Notice of Allowability	Application No.	Applicant(s)
	10/668,794	ECKSTEDT, PAUL D.
	Examiner	Art Unit
	Eric Culbreth	3616

EXAMINER'S AMENDMENT

FIG. 2

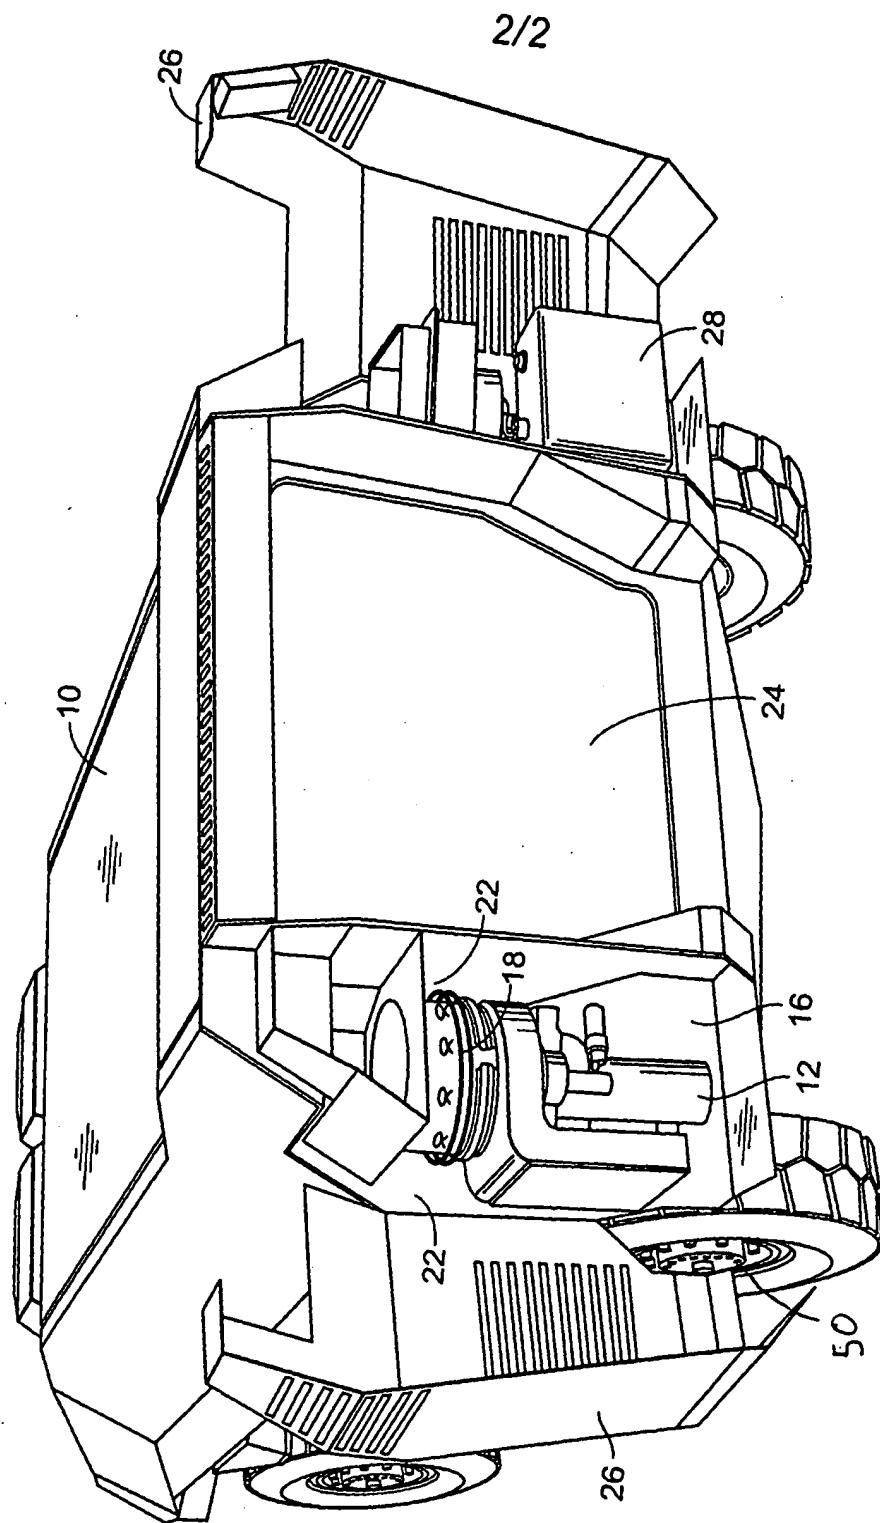
2. The following changes to the drawings have been approved by the: Figure 2 was amended to add reference numeral 50 schematically representing an electric motor. In order to avoid abandonment of the application, applicant must make these above agreed upon drawing changes.
